SUBDIVISION COMMITTEE
METROPOLITAN AREA PLANNING COMMISSION

STAFF REPORT
(Final Plat)

S/D 96-71 - KNETZER 2ND ADDITION

Sketch Plan - Knetzer's 2nd. Addition

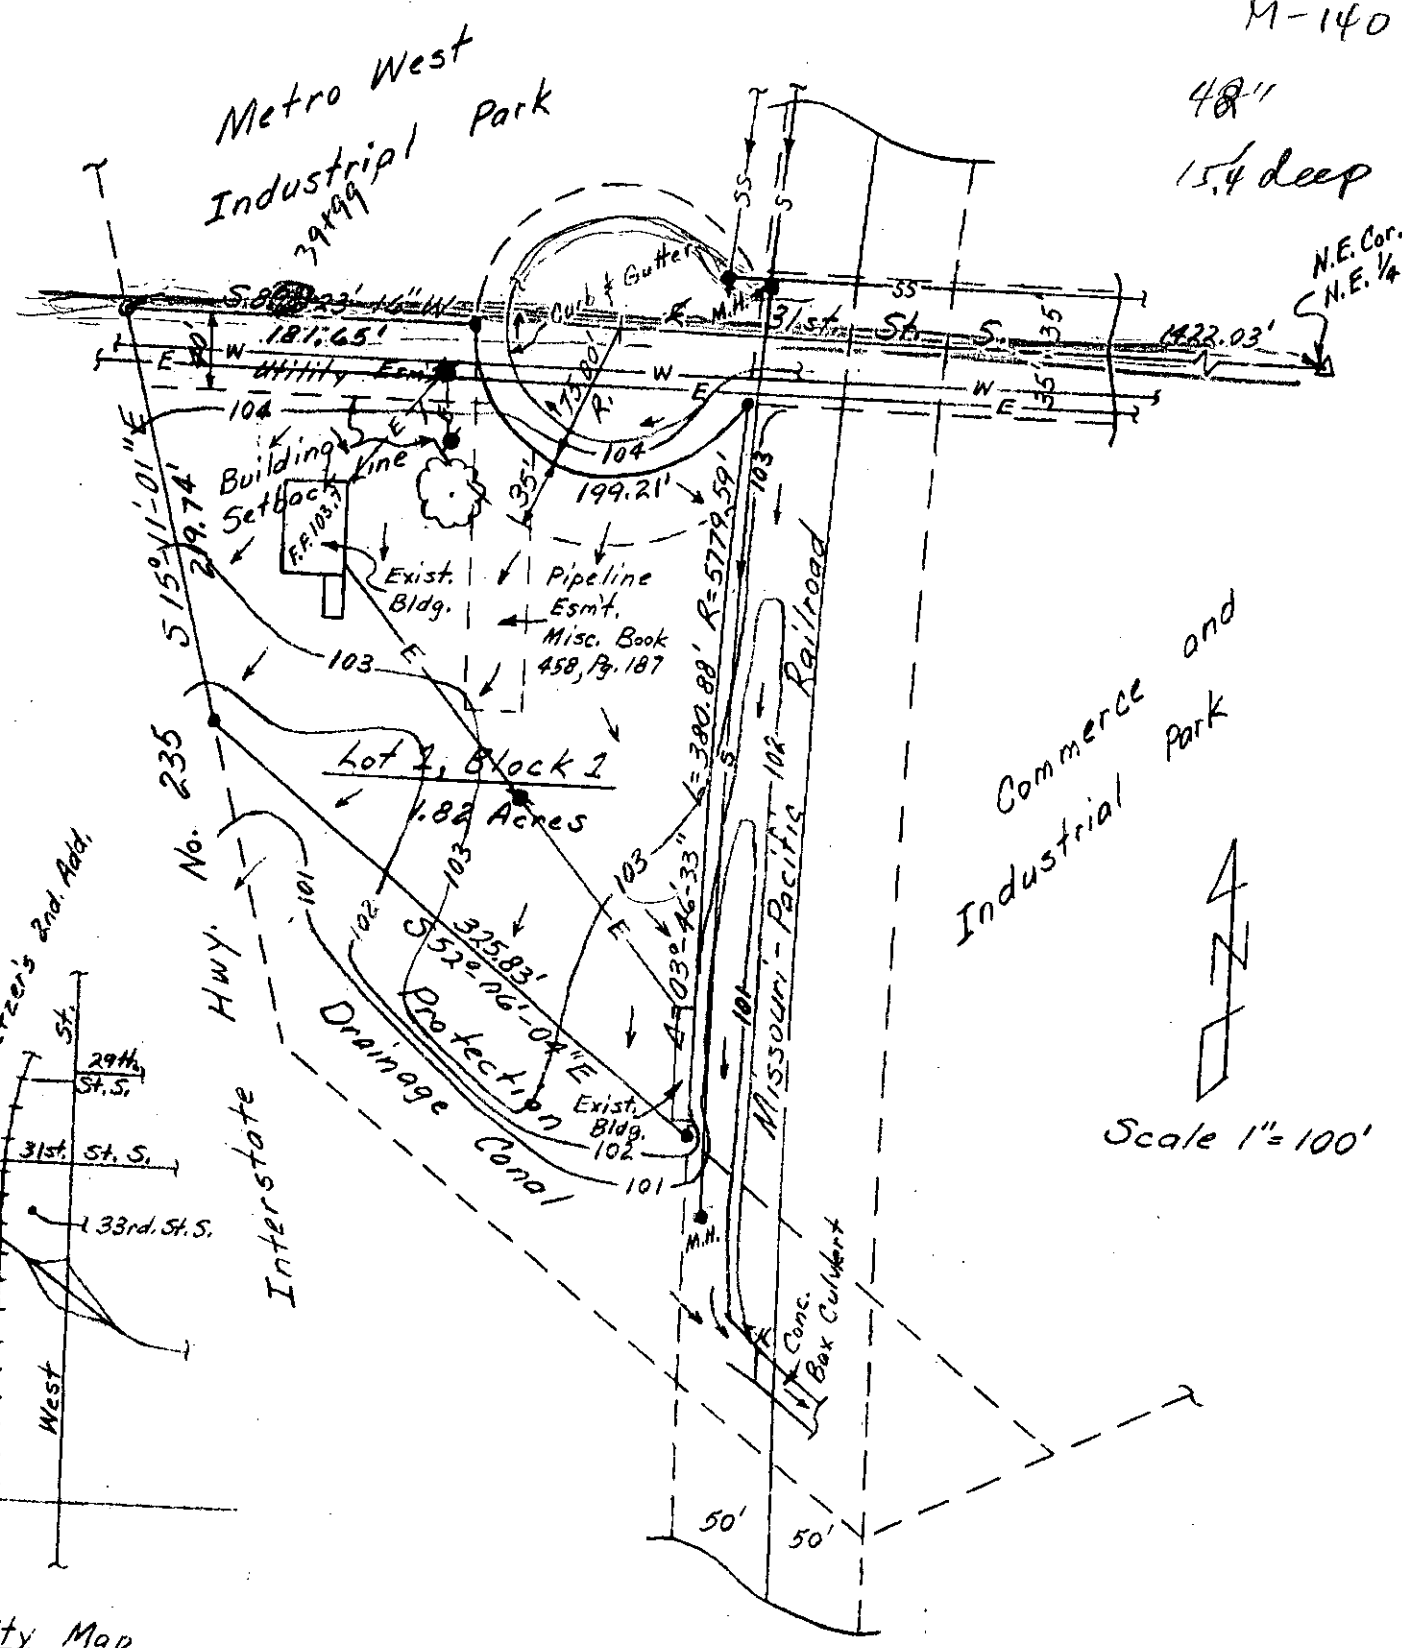
- A. In regard to existing conditions at this location, City Engineering needs to indicate requirements for street paving, water, and sanitary sewer improvements. That is, are new guarantees required, are any projects needing to be abandoned and/or redesigned and so forth.
- B. Both the face of this plat and the plat's text shall note the dedication of right-of-way for the turnaround shown on this site.

In order to provide the turnaround for the northern half of this street, the applicant shall obtain by separate instrument such right-of-way from the adjoining property. While such a dedication appears to be available with the vacation case (V-1978), since that case has not yet been completed, an updated dedication specifically provided for this platting situation will be needed.

- E. For the pipeline easement on this property, the final plat shall include in the labeling of the easement the name of the company benefiting from the easement agreement.

- F. The applicant shall submit a copy of the instrument which establishes the Texaco-Cities Service Pipe Line Easement on this property. The applicant's agent shall determine any setback requirements from the pipeline by researching the text of the pipeline agreement. If a setback from the pipeline easement is provided for in the pipeline easement agreement, it shall be indicated on the face of the plat.

1. The 35-foot building setback shall be continued around the cul-de-sac to the north property line.
 2. The tie point shall be more precisely described. Both the section-range-townships need to be referenced and the noted distance more clearly defined. More appropriately, the

distance from the section corner to the easterly line of the plat (west line of the Railroad right-of-way) and then down to the Lot's northeast corner along the Railroad right-of-way would be clearer means for indicating the tie point.

3. The direction South shall be added to the street name for 31st Street on the face of the plat.
 4. The MAPC chairman shall be indicated as John C. Frye.

5. For Interstate I-235, the appropriate condemnation case number shall be shown and the face of the plat shall note that "complete access control" exists from this site to the Interstate.
